AGENDA
CITY PLANNING COMMISSION

City Hall - Council Chambers
6131 Taylorsville Road
January 14, 2025
6:00 P.M.

MINOR CHANGE - The applicant, FERGUSON CONSTRUCTION, is requesting approval of a Minor Change for an 11,722 SF building addition for a new gymnasium and additional storage. Property is located at 7251 Shull Road (Case MC 25-01).

DETAILED DEVELOPMENT PLAN - The applicant, TJL-CES, LLC, is requesting approval of a Detailed Development Plan for 0.98 acres to construct a Domino's Pizza (pick-up and delivery only) at 8920 & 8960 Old Troy Pike (Case DDP 25-02).

C-1.1
DEMOLITION
PLAN

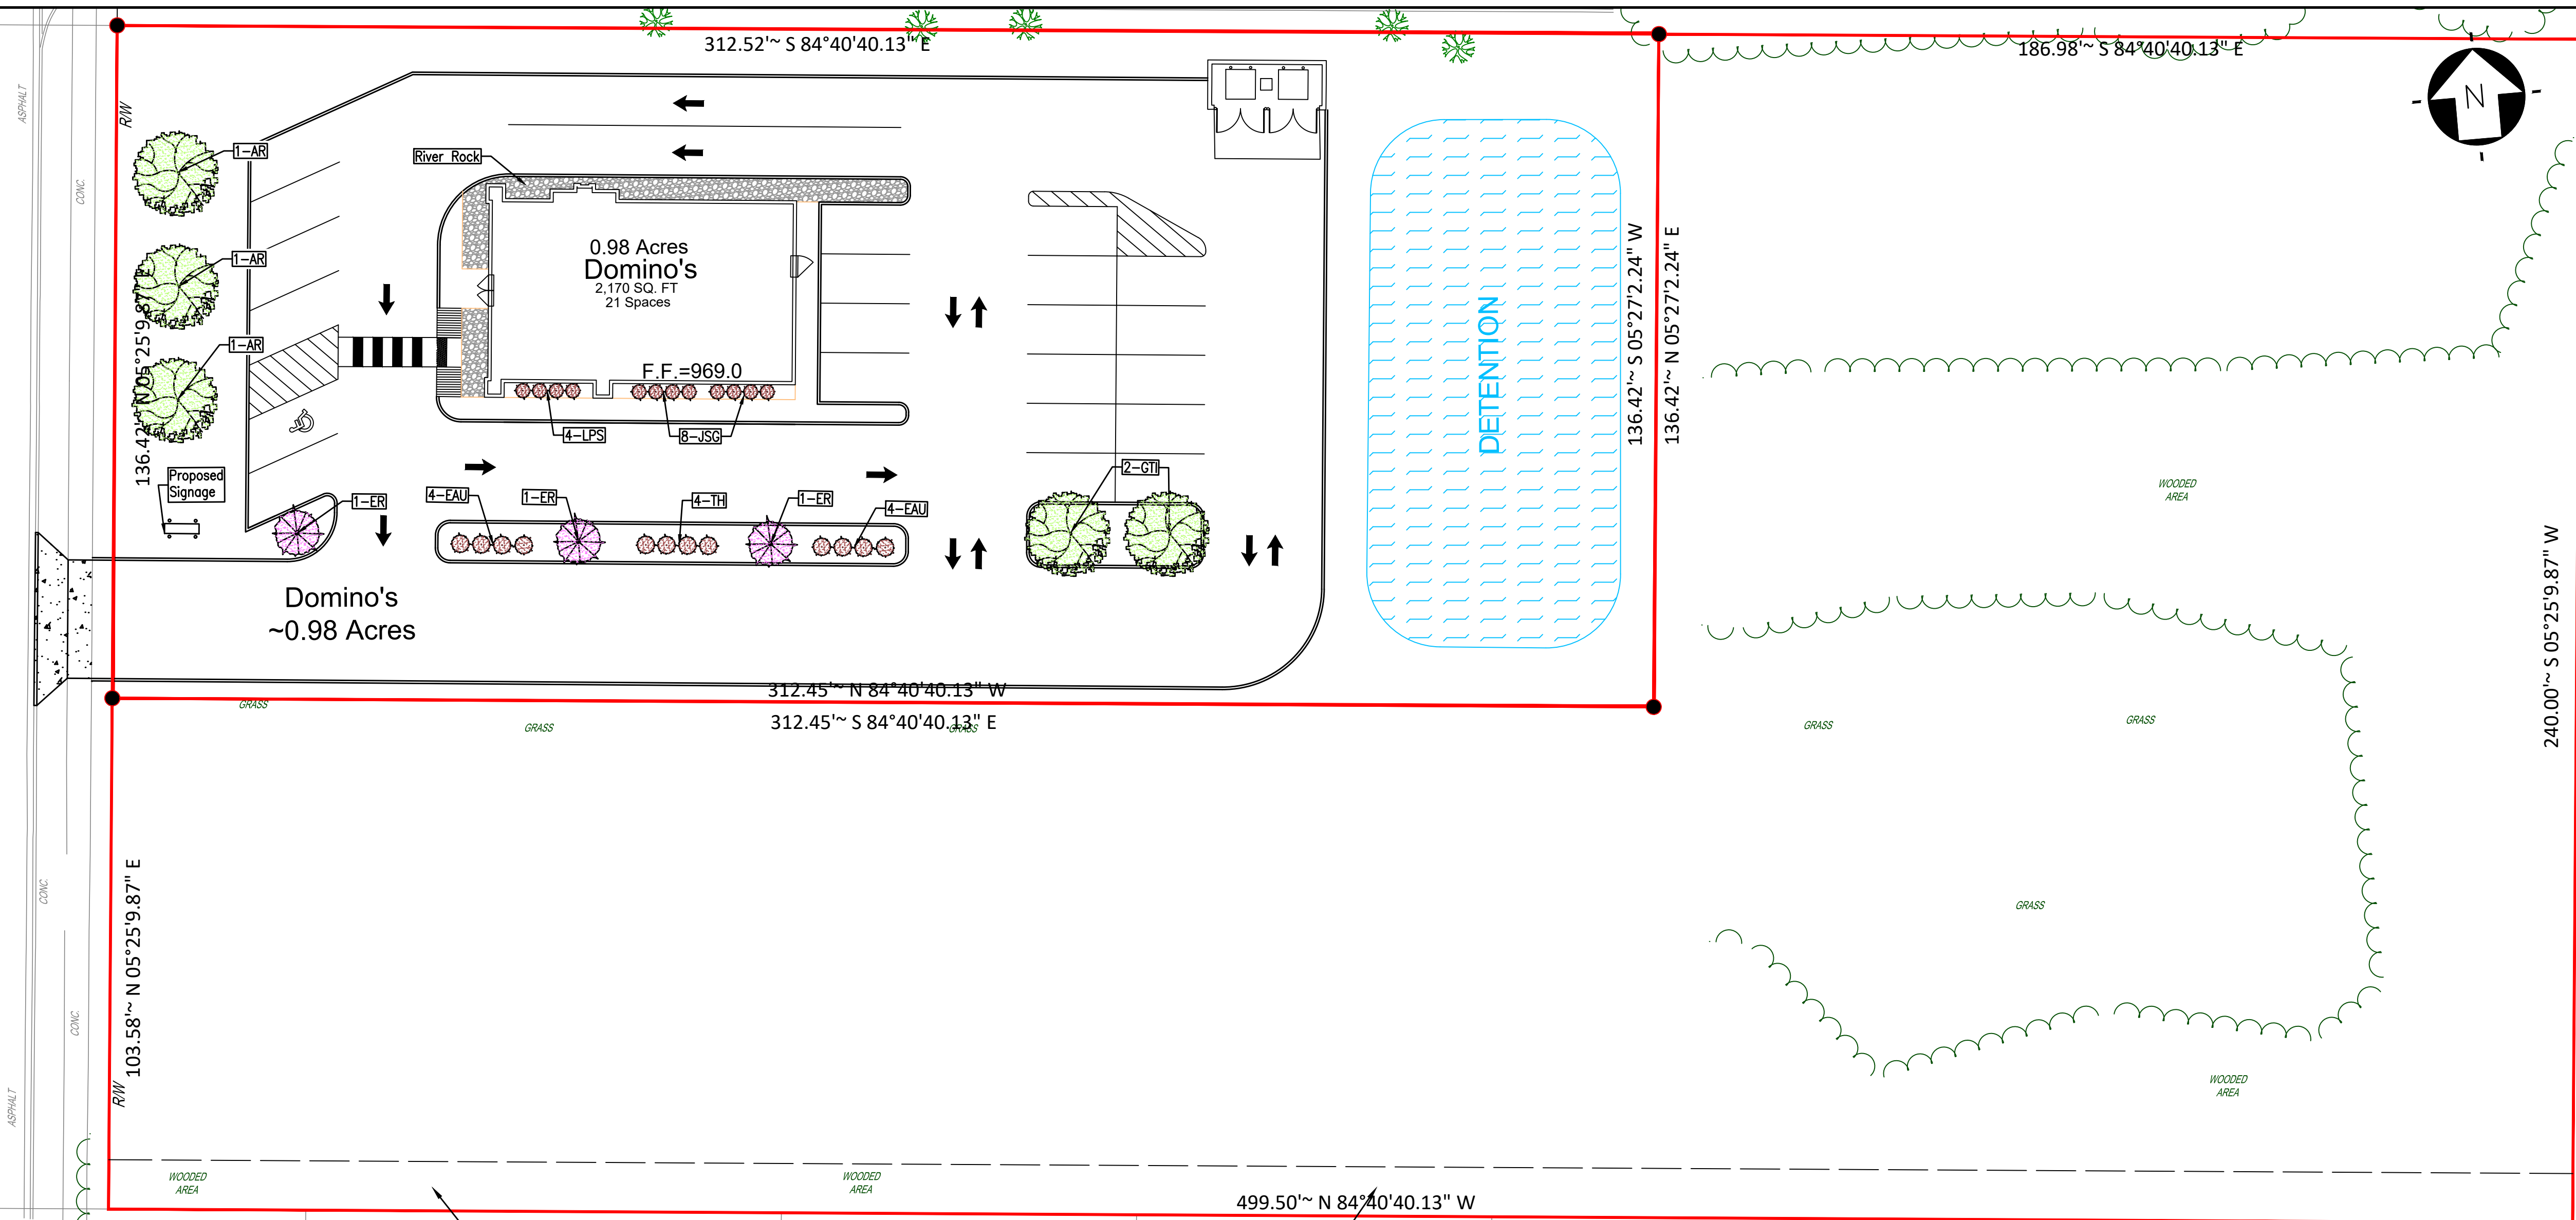
The applicant is proposing a 10-foot tree line buffer on the south side of the property and 175-foot non-disturbance area on the east side of the property. Staff has requested the applicant enlarge the south buffer to 20-feet. This additional buffer will provide greater protection for the existing trees until a detailed development plan is submitted for this lot.

1. The south tree line buffer area shall be increased to 20 feet, and a tree survey shall be conducted to evaluate the species and health of existing trees within this buffer area. All other elements of the demolition plan shall remain unchanged.
2. Signs shall conform to Chapter 1189.
3. Additional shade-tolerant plant material will be installed along the north wall to soften the building façade.

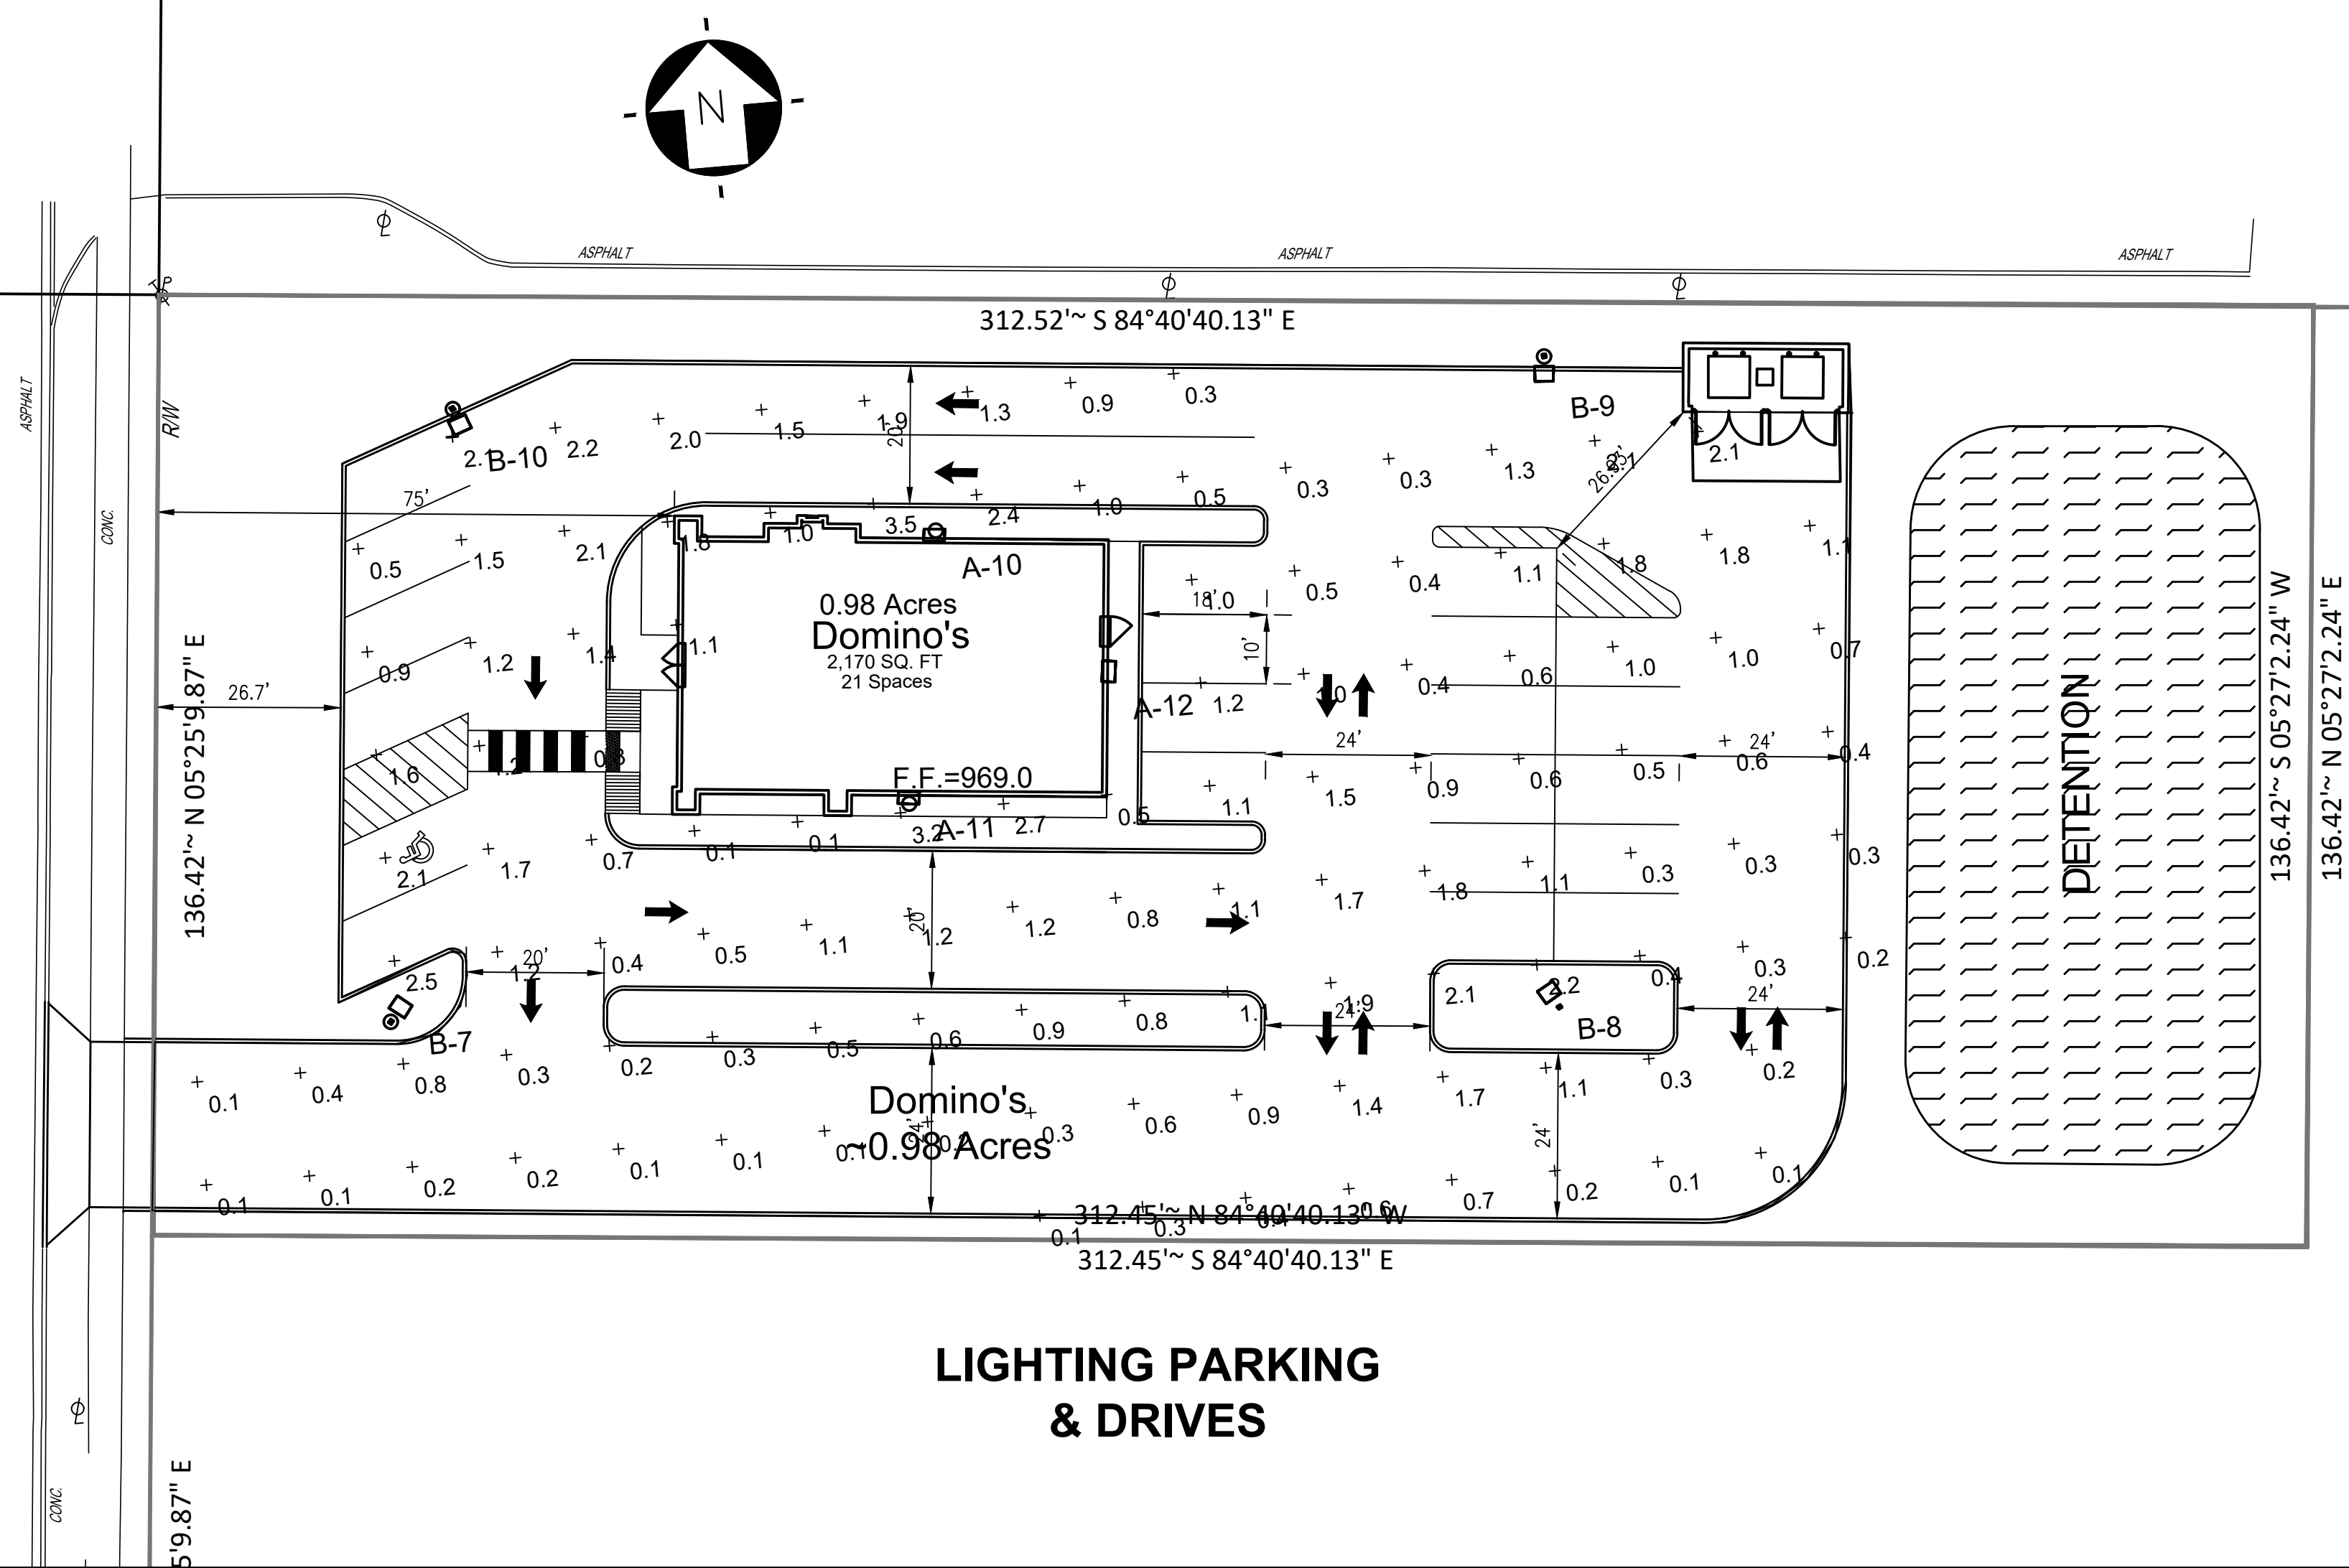
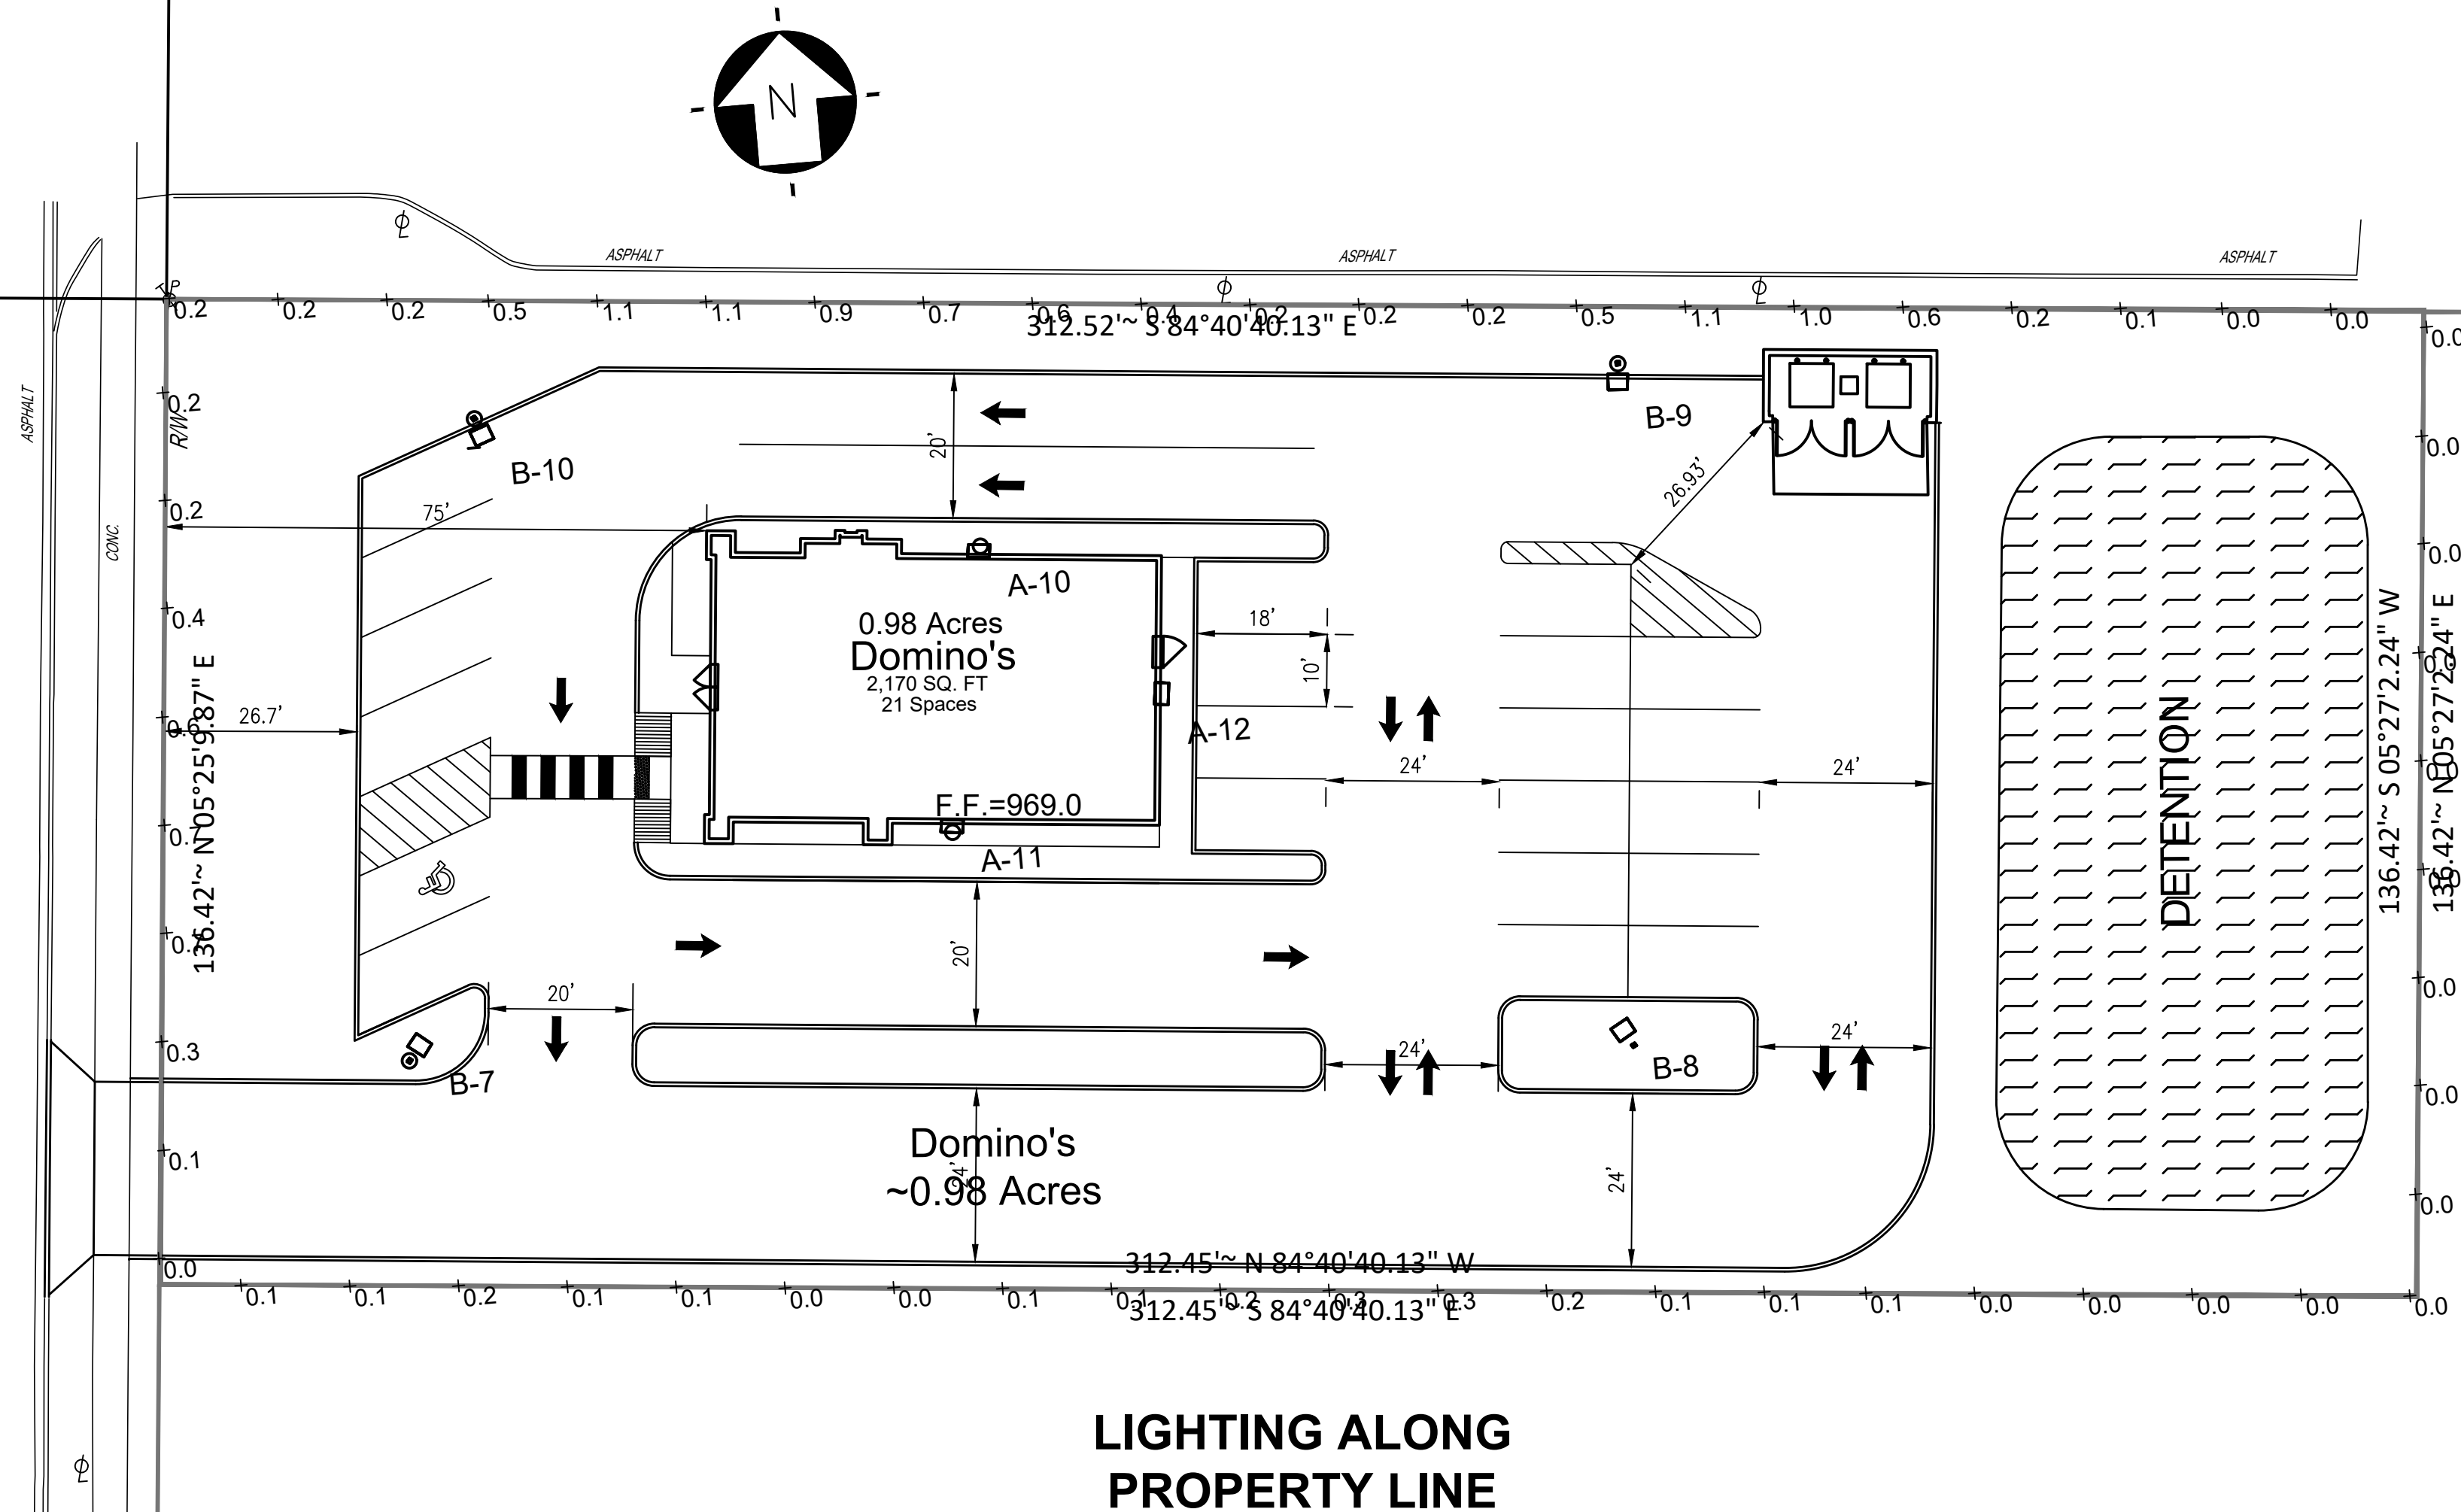
- The application illustrates a mixture of street, shade and ornamental trees, along with a mixture of shrubs. The landscaping plans meet the zoning code requirements.
- Staff has requested the applicant to provide additional plant material along the north side of the building to soften the north façade.
